Subject: RE: Faceby Lodge

Please find attached Piggery elevations as existing as requested in your email below.

I'm just working through the plans and don't seem to be able to find a plan showing the existing elevations of the piggery building.

Bldg G North Ele

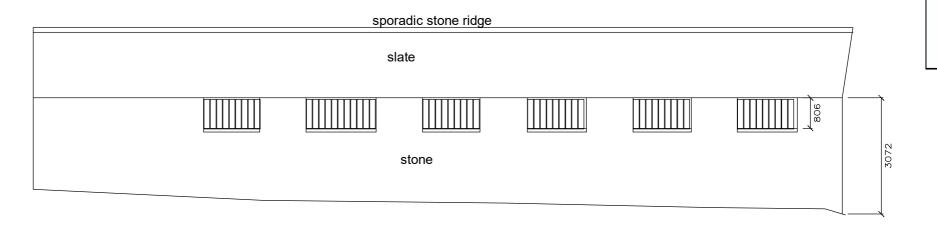
I'd be grateful if you would send that through. The plans suggest a number of window openings will be blocked, and I can see these openings from my photos – I would suggest that if the openings are being blocked up, they should be done so with recessed stone work to retain some interest in the elevation.
